CPP Project 11472

Project: Barangaroo C1

Please find herein an overview of expected wind conditions and potential mitigation strategies for the pedestrian environment around Commercial Building 1, Barangaroo. Specifically, this letter will address the ground level conditions at the north end of the development, considering the proposed mitigation structures in the context of previous wind tunnel test data.

Figure 1: Pedestrian wind speed measurements with Lawson comfort ratings - site

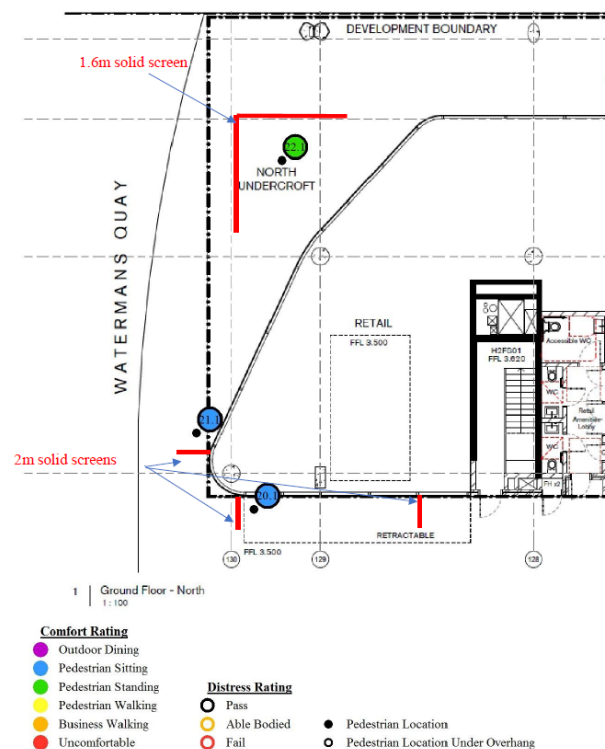
CPP has conducted wind tunnel tests for the site, for which further details may be found in Cermak Peterka Petersen (2017). The results are summarised in Figure 1. Without the inclusion of local mitigation measures, the northern forecourt area is rated as Pedestrian Standing under the Lawson comfort criteria (Locations 3-5, Figure 1).

Figure 2: Pedestrian wind speed measurements with Lawson comfort ratings – north forecourt

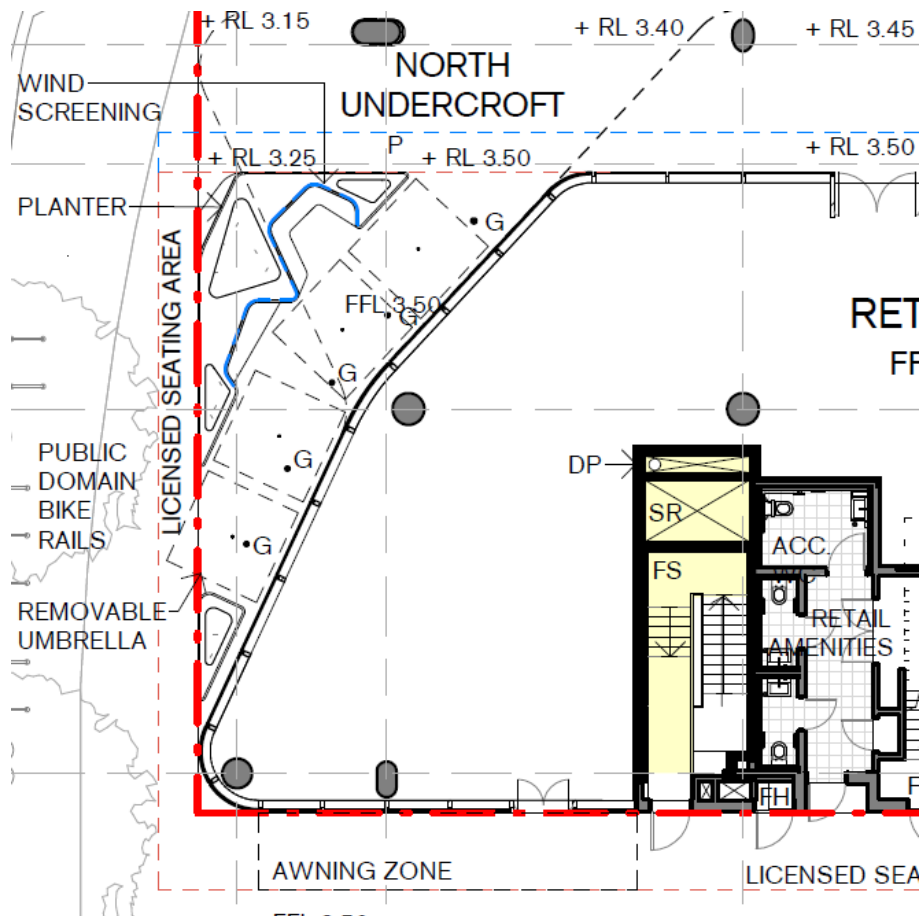
Representative mitigation structures were tested for this area, as indicated in Figure 2. These comprised a 1.6 m vertical screen at the north-eastern seating area, and smaller 2 m screens at the north-western corner. These were shown to be effective in reducing wind speeds – conditions in this area are mostly suitable for Pedestrian Sitting under Lawson, with the north-east corner exceeding the sitting threshold by a small margin.
